## System Impact Assessment Report

**Project:** *Third Line T.S. 115 kV Refurbishment*

**Applicant:** Great Lakes Power Limited – Transmission  
Division

*CAA ID 2009-355*

Figure 3 - Third Line TS 115 kV Proposed Configuration

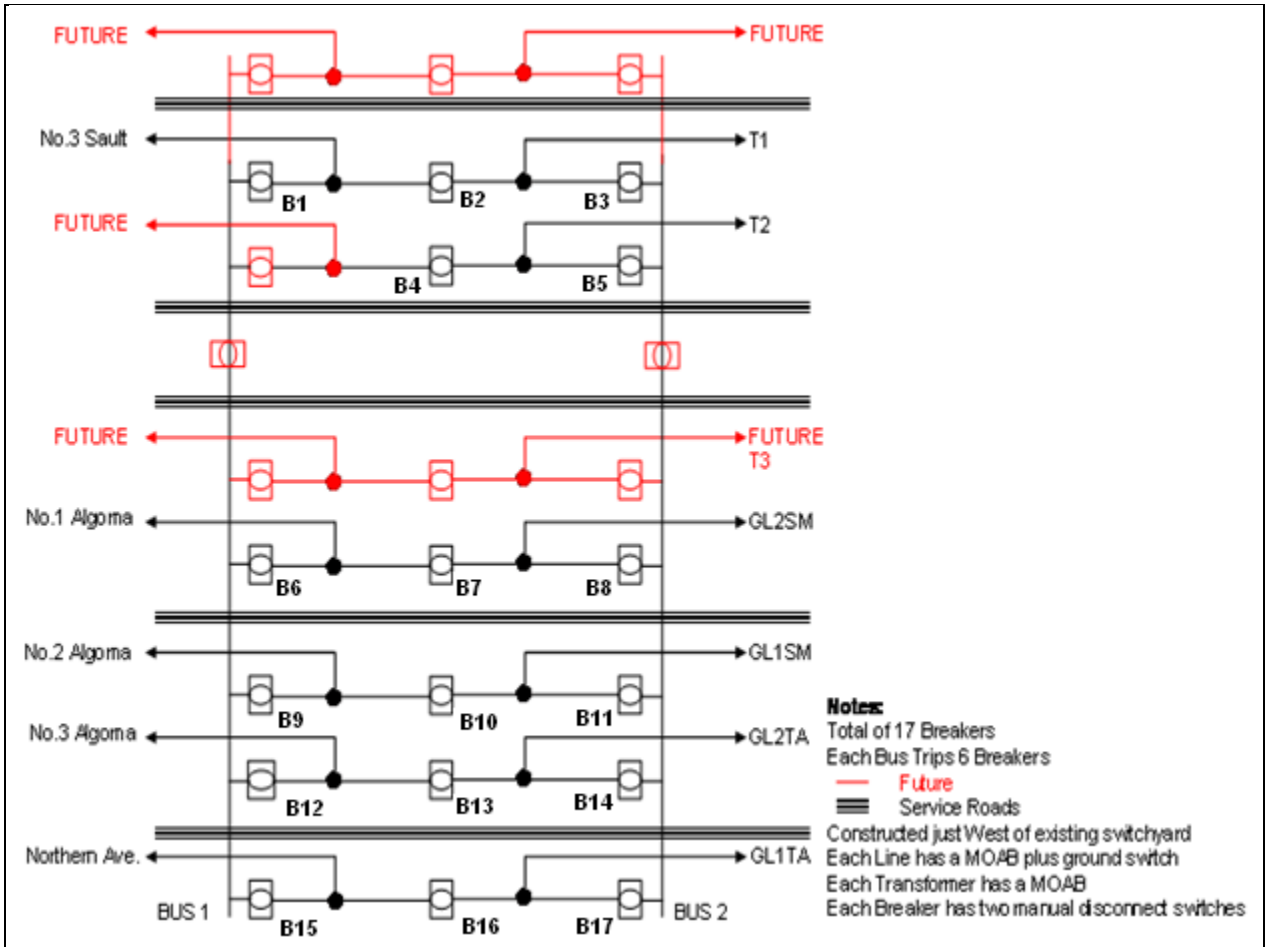
The proposed configuration change will replace the existing 15 breaker system with a 17 breaker, one and a half breaker, system. The new configuration will ensure that each 115 kV transmission element at Third Line TS will terminate on dedicated positions on a three breaker diameter. This layout allows for the isolation of a faulted element without removing other elements from service, thus improving the reliability of operation. Also, in the event of a breaker failure, no more than one of the Algoma circuits or one of Third Line Transformers T1/T2 will be removed from service (in addition to the faulted element).

The proposed configuration change will meet all other IESO guidelines for station layout as outlined in Appendix B of “Ontario Resource and Transmission Assessment Criteria (ORTAC)”. Specifically, 6 high voltage breakers are tripped for a fault to either of the 2 buses, satisfying the IESO requirement. The proposed connection will allow for convenient future expansions of Third Line TS while still meeting IESO station layout guidelines.

The Transmission System Code (TSC), Appendix 2 states that 115 kV fault levels can have maximum symmetrical value of 50kA. GLPL has indicated that the proposed circuit breakers have a capacity of only 40kA.

The installation of 40 kA short circuit capability circuit breakers instead of 50 kA circuit breakers is a risk assumed completely by Great Lakes Power Limited – Transmission Division. Should future system changes result in fault currents greater than 40 kA, Great Lakes Power Limited – Transmission Division will be required to change the circuit breakers at their expense.

It is recommended that Notification of Conditional Approval for connection be issued to Great Lakes Power Limited – Transmission Division, subject to IESO’s Requirements for Connection listed below, and any further requirements that may be identified by GLPL in the Customer Impact Assessment.
